COUNCIL ASSESSMENT REPORT

Panel Reference	PPSSNH-449
DA Number	297/23
LGA	North Sydney Council
Proposed Development	Redevelopment of the site at 617-621 Christie Street, St Leonards for a 50-storey mixed-use development comprising retail and commercial uses within the podium, residential apartments above as well as basement car parking and loading and servicing areas.
Street Address	617-621 Pacific Highway, St Leonards
Applicant/Owner	Applicant – Mr. Edmand Lee Owners – Anson City Developments 1
Date of DA lodgement	20 October 2023 Amended 6 September 2024
Total number of Submissions Number of Unique Objections	One hundred and seventeen (117) submissions received.
Recommendation	Refusal
Regional Development Criteria Schedule 6 of the SEPP (Planning Systems) 2021	Regional Development is defined in Schedule 6 of State Environmental Planning Policy (Planning Systems) 2021 Development with a capital investment value (CIV) over \$30 million is classified as “Regional”. The CIV of this development as outlined in the application is \$187,179,158.00 excluding GST.

INDICATIVE FLOOR PLAN - 601 PACIFIC HIGHWAY

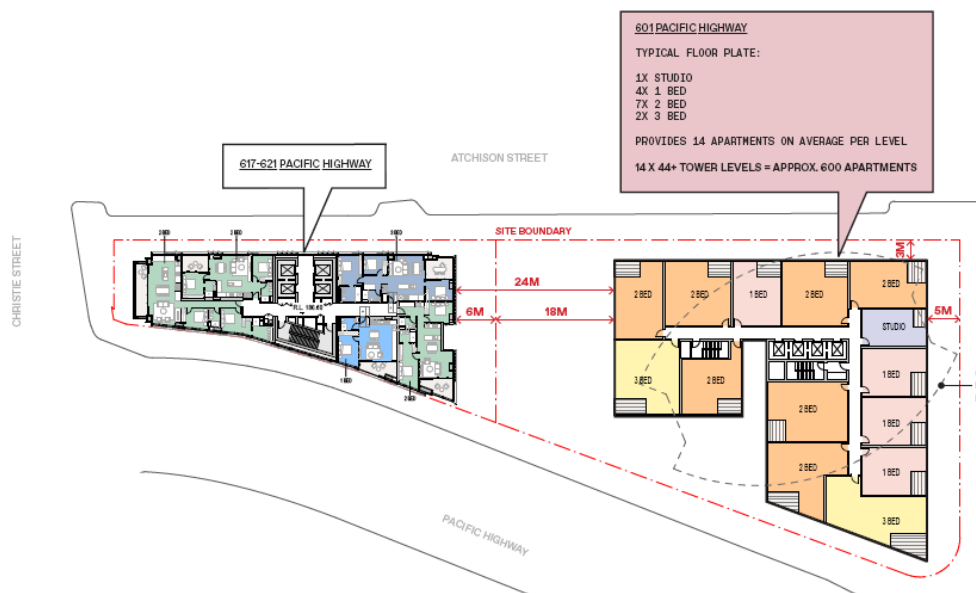
Whilst an indicative floor plan has been provided based on the very limited information provided in association with a future SSD, the adjoining site should not be burdened to provide a 18m setback to the benefit of the subject site. Additionally, the matter of the eastern setback was raised in the pre-applicant minutes.
